VILLAGE OF WINDSOR
BOARD RESOLUTION 2019-74

APPROVAL OF A CERTIFIED SURVEY MAP, SITE PLAN AND EXTENSION OF NORTH TOWNE ROAD ALL FOR PROPERTY LOCATED IN THE SE ¼ OF THE SE ¼ OF SECTION 29,
IN THE VILLAGE OF WINDSOR, DANE COUNTY

To:	Village of Windsor Board
Cc:	Robert Wipperfurth, Tina Butteris, Christine Capstran, William Cole
From:	Amy Anderson Schweppe, Jamie Rybarczyk
Rpt Date:	July 12, 2019
Mtg Date:	July 18, 2019
Submtl Date:	May 21, 2019
Aprvl Date:	August 19, 2019
Re:	The Terraces - Certified Survey Map, Site Plan Review, & North Towne Road Extension Request

SHEET NUMBER:
C7.0

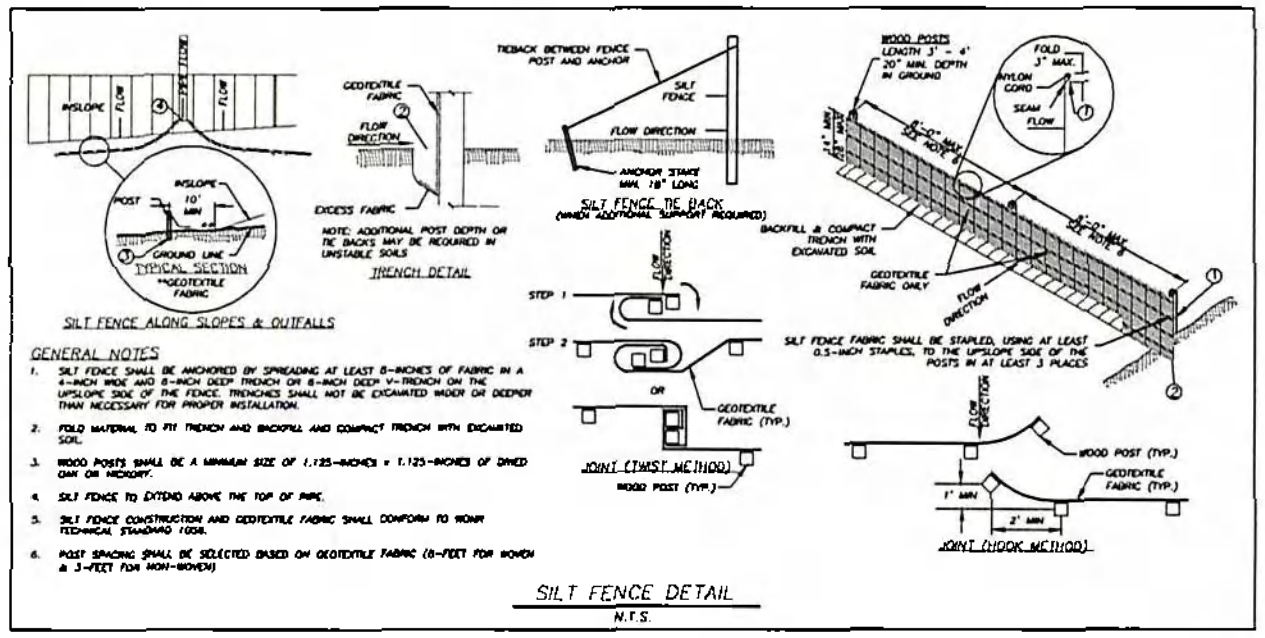
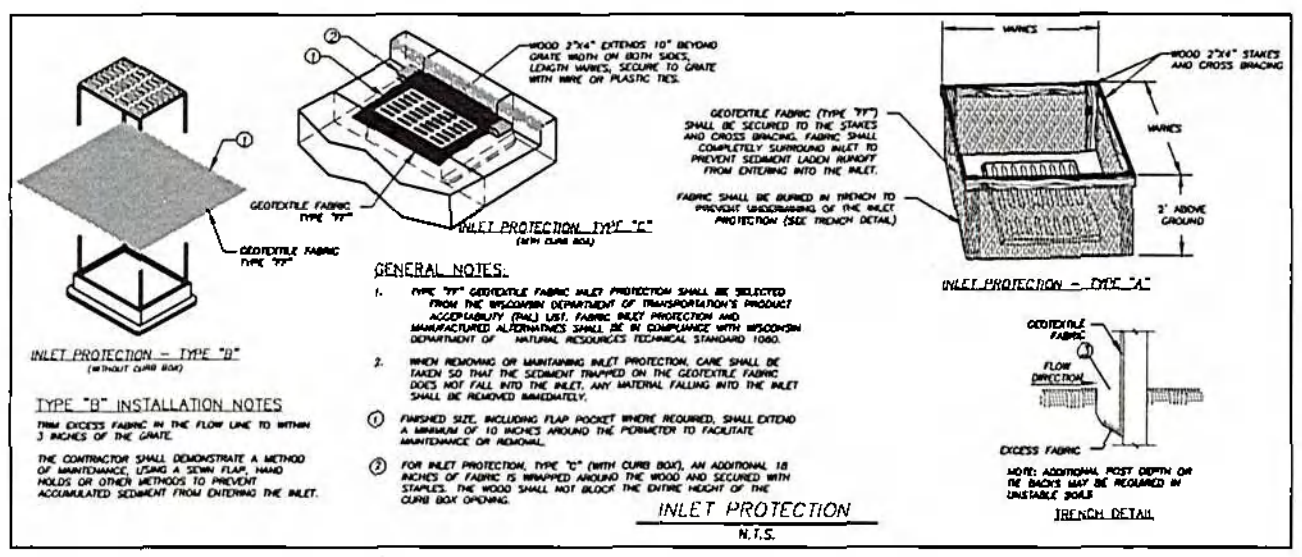
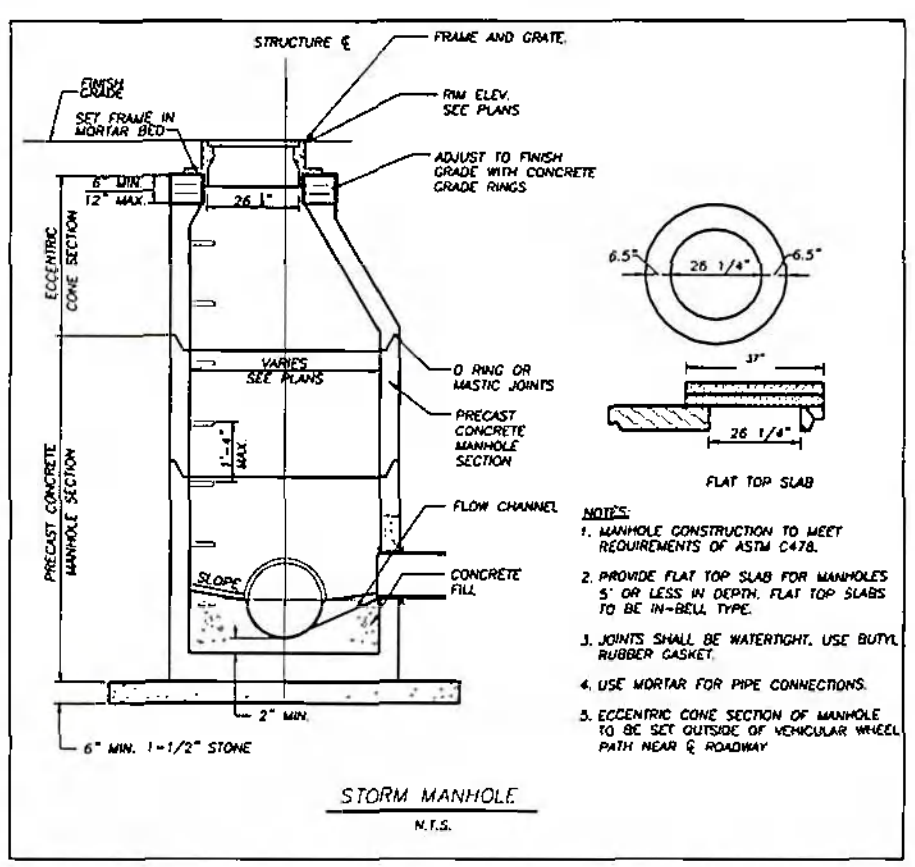
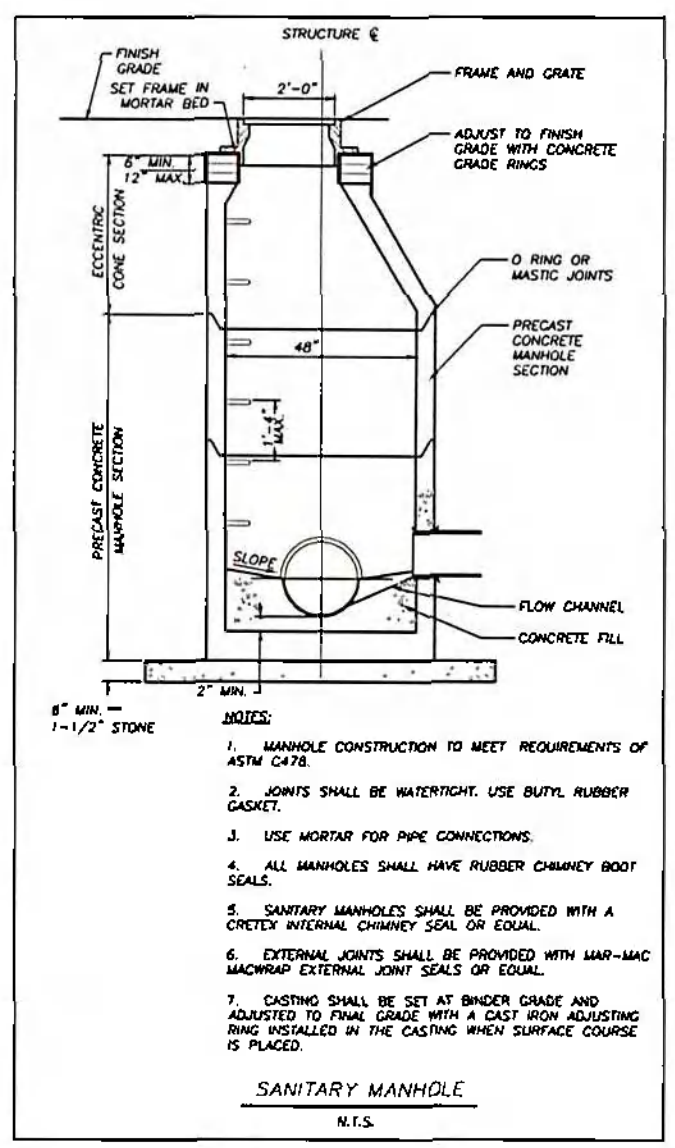
2. *Windsor Crossing Phase II Drawing Comments*
   a. Sheet C7.0 - Sanitary and Storm MH to be installed without manhole steps.
   b. Sheet C7.1 - General Utility Notes 1: Change Utility name from Windsor Utility District No. 1, to "Windsor Utility".

SHEET NUMBER:
C2.0

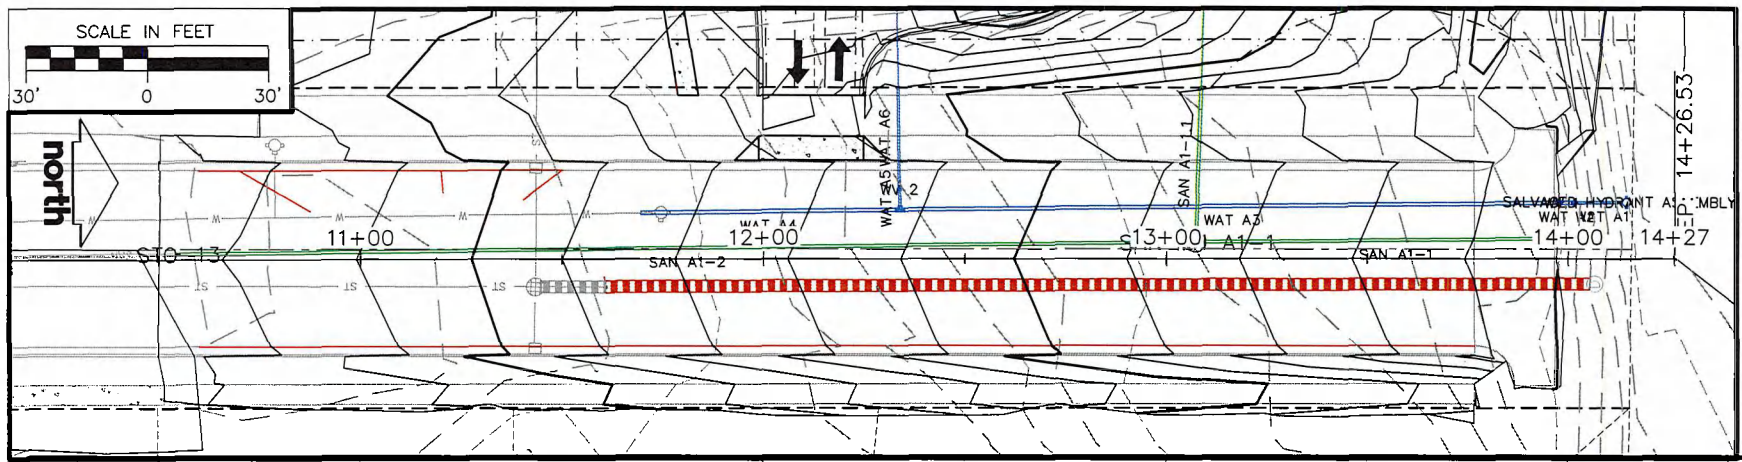
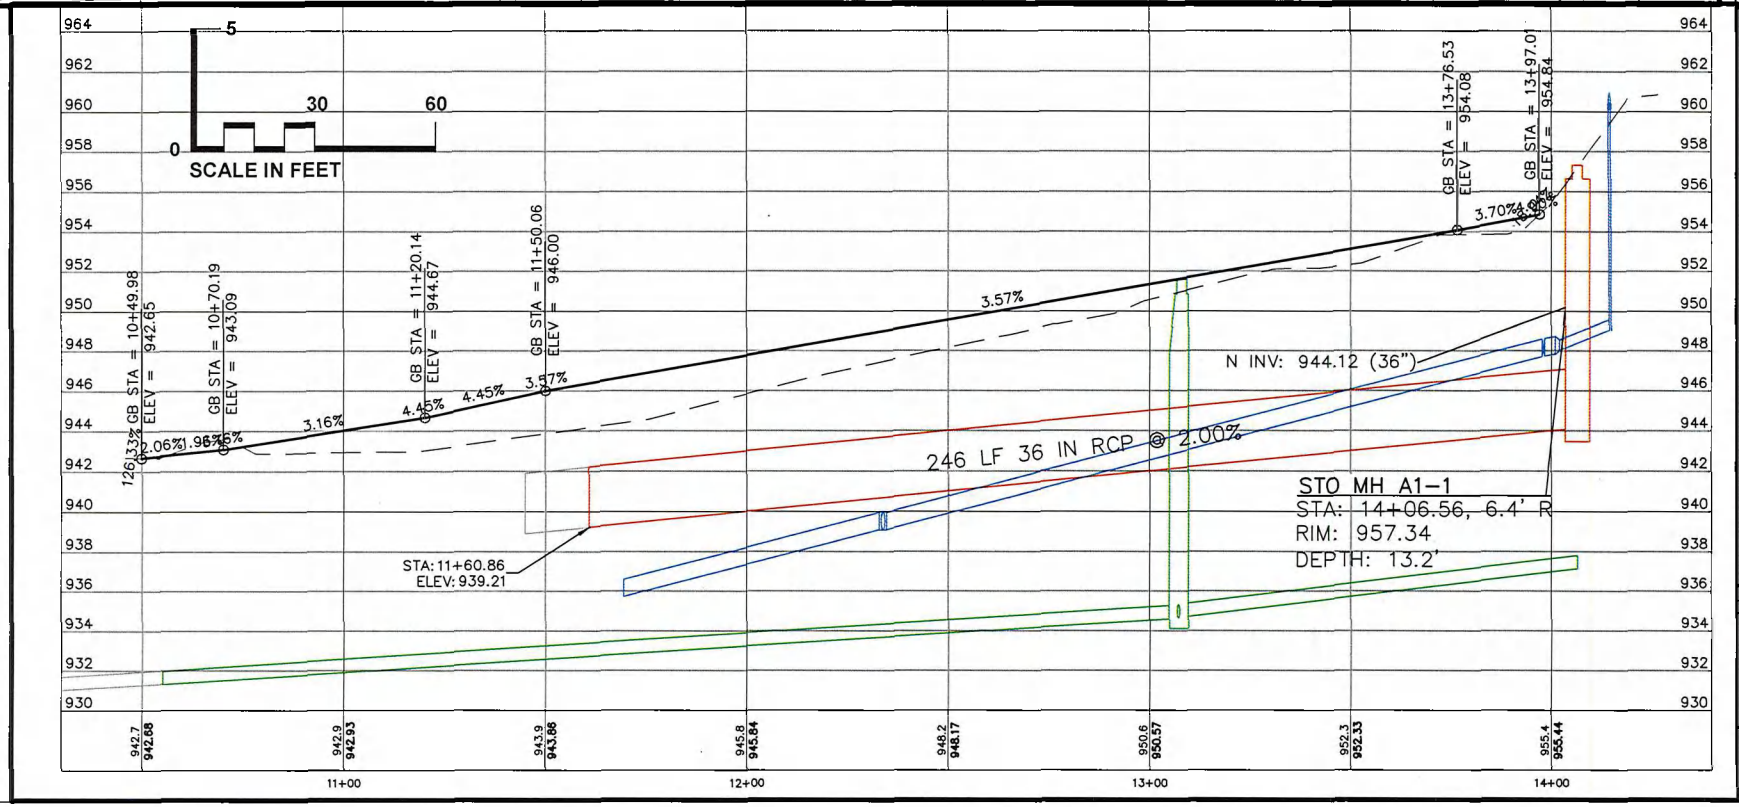
c. Sheet 2-0 - Relocate 10" gate valve to water connection at 11+69. This will allow for pressure testing. Re-install hydrant "with 6-inch hydrant isolation valve" at end of watermain near Station 14+14.

d. Sheet 2-0 - Install a valve on new 6-inch service to Building 4.
   e. Sheet 3-0 - The Cross Section shows 10' path located 2' inside ROW. Ordinance language would suggest locating path to 1' inside ROW. Reason for use of 2' should be clarified.

SHEET NUMBER:
C3.1

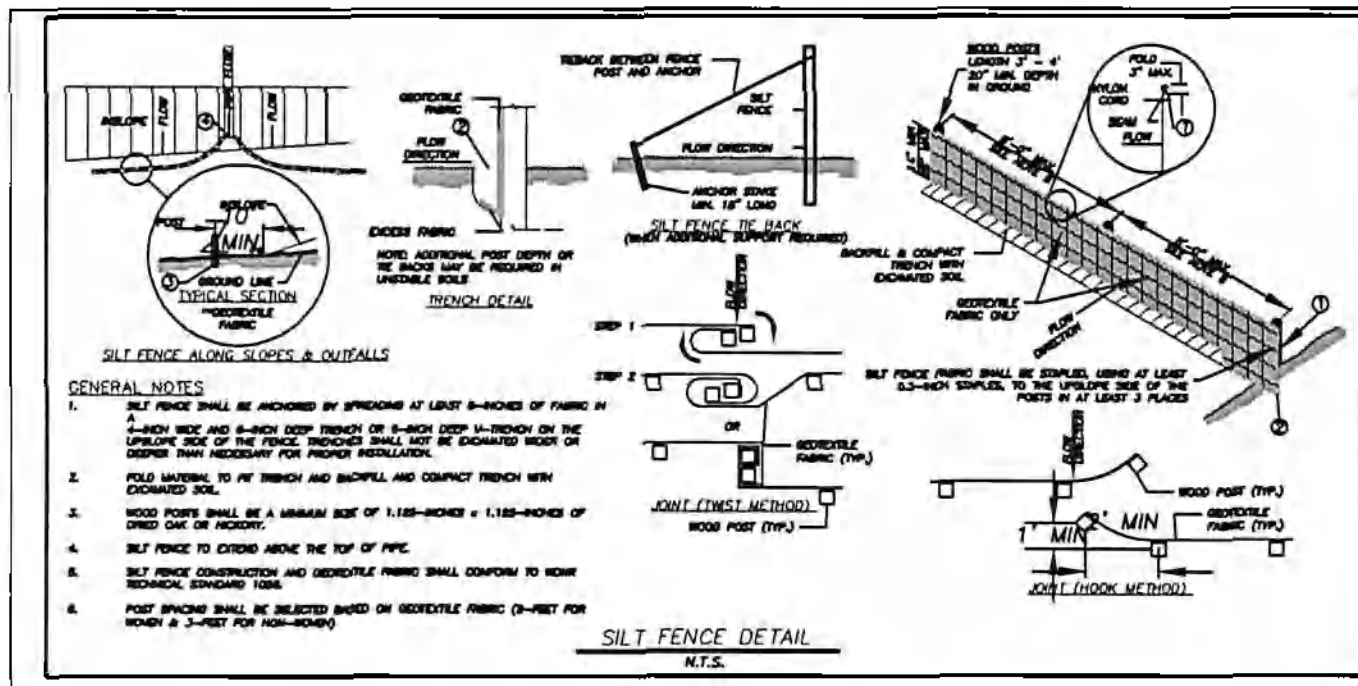
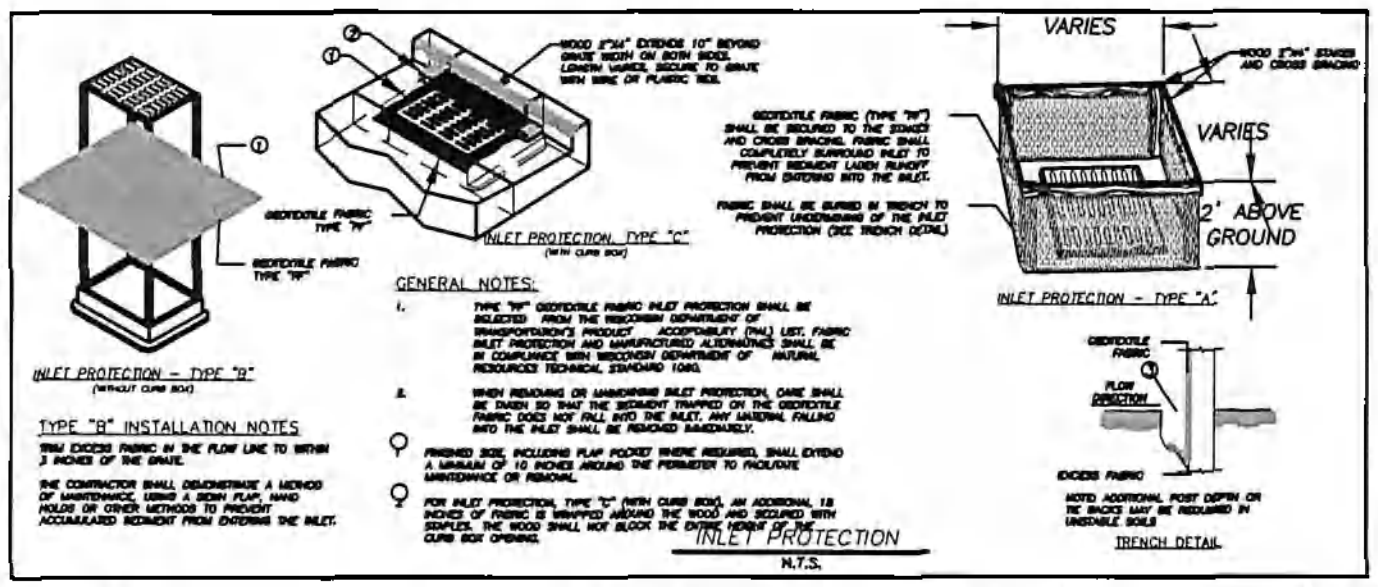
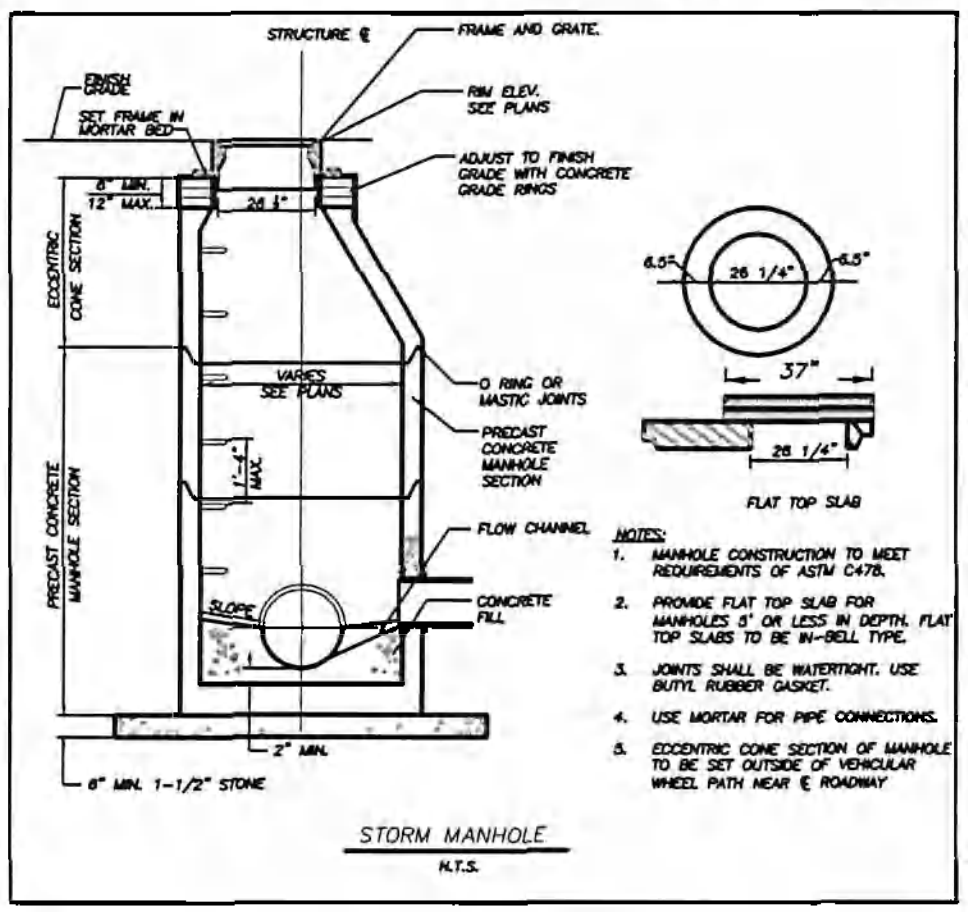
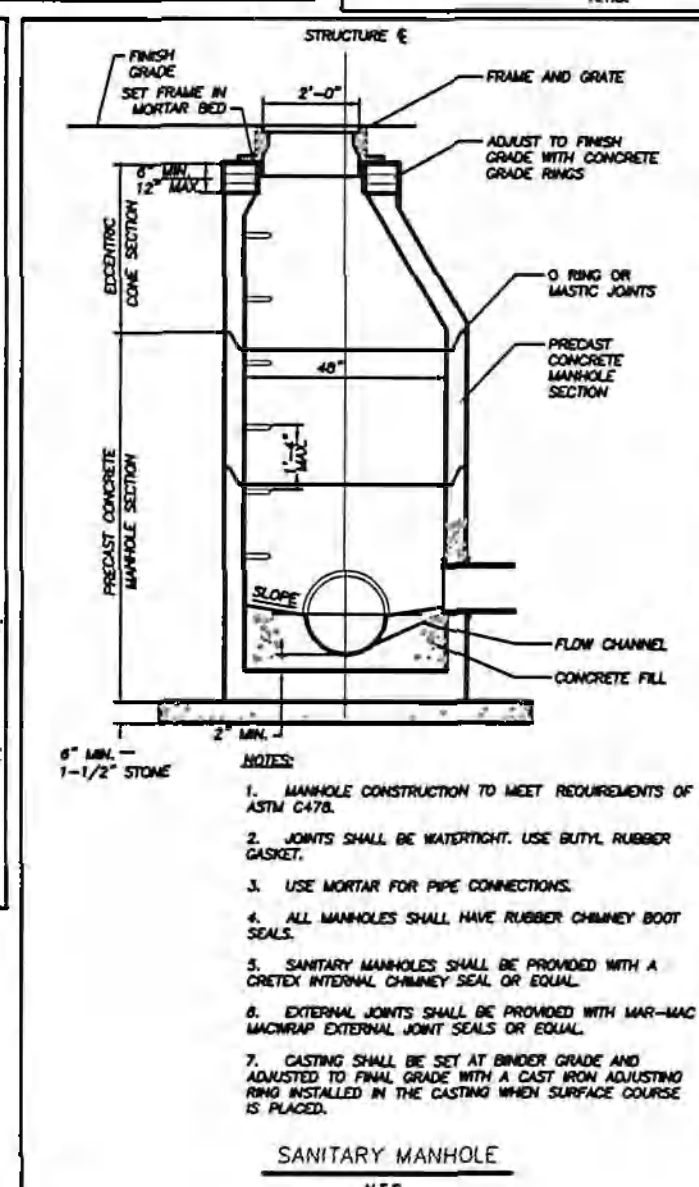
f. Sheet 3-1 - Sanitary and Storm MH to be installed without manhole steps.
   g. Sheet 3-2 - General Utility Notes 1: Change Utility name from Windsor Utility District No. 1, to "Windsor Utility".

TEMPORARY TURN AROUND DETAIL

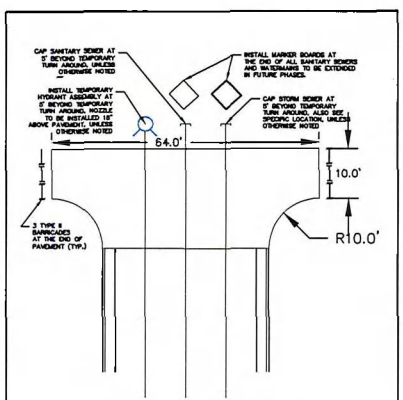
h. Sheet 3-2 - Temporary Turn Around Detail: Change from Hammerhead to 40' radius circular turnround. Adjust notes and other features accordingly.
